Access Compliance Report

Public Rights-of-Way

(Curb Ramps)

Intersection ID: 14076	Main Street: W_TYVOLA_RD	Cross Street: WEST_BV	Location: SW
ADA ID: D15C585806F5	Ramp Type: Perp	Initial Pass/Fail: Fail	Overall Compliance: No
Severity Score: 33.75			
Codes/Mitigation Info/Possible Solution		Field Measurements/Component Compliance

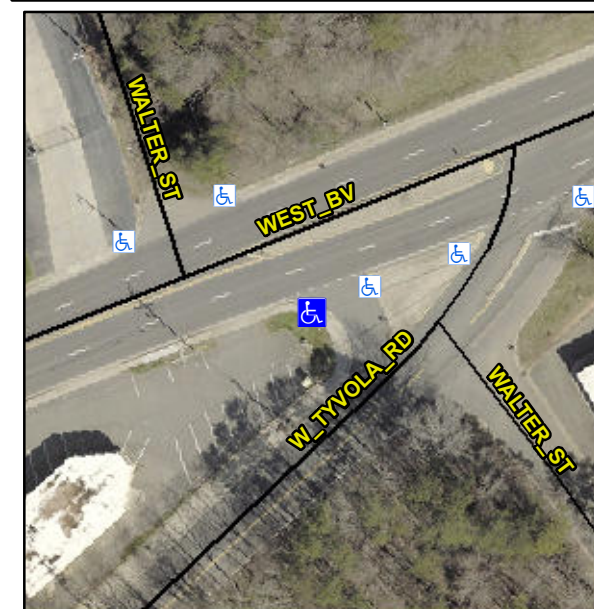
R304.5.1, R304.5.3

Compliance	Description	Data	Compliance	Description	Data
N/A	Ramp Length (in)	50.0	Yes	Ramp Slope (%)	6.4
No	Ramp Width (in)	36.0	No	Ramp XSlope (%)	8.4
N/A	Flare Type LT	N/A	N/A	Flare Type RT	N/A
N/A	Flare Slope LT (%)	N/A	N/A	Flare Slope RT (%)	N/A
N/A	Flare Traversable LT?	N/A	N/A	Flare Traversable RT?	N/A
N/A	Landing Length (in)	N/A	N/A	DWS Provided?	N/A
N/A	Landing Width (in)	N/A	N/A	DWS Contrast?	N/A
N/A	Landing Slope (%)	N/A	N/A	DWS Length (in)	N/A
N/A	Landing X Slope (%)	N/A	N/A	DWS Full Width?	N/A
N/A	Landing Curb? (Y/N)	N/A	N/A	DWS Offset (in)	N/A
N/A	Shared Landing?	N/A			
N/A	Gutter Ponding?	N/A	N/A	Gutter Slope (%)	N/A
N/A	Gutter Lip Ht (in)	N/A	N/A	Gutter X Slope (%)	N/A
N/A	Painted X Walk1?	No	N/A	Painted X Walk2?	N/A
	X Walk 1 Direction	To E		X Walk 2 Direction	N/A
N/A	X Walk 1 Width (in)	N/A	N/A	X Walk 2 Width (in)	N/A
	X Walk 1 Slope (%)	5.7		X Walk 2 Slope (%)	N/A
	X Walk 1 X Slope (%)	15.0		X Walk 2 X Slope (%)	N/A

Remove & Replace Entire Ramp.
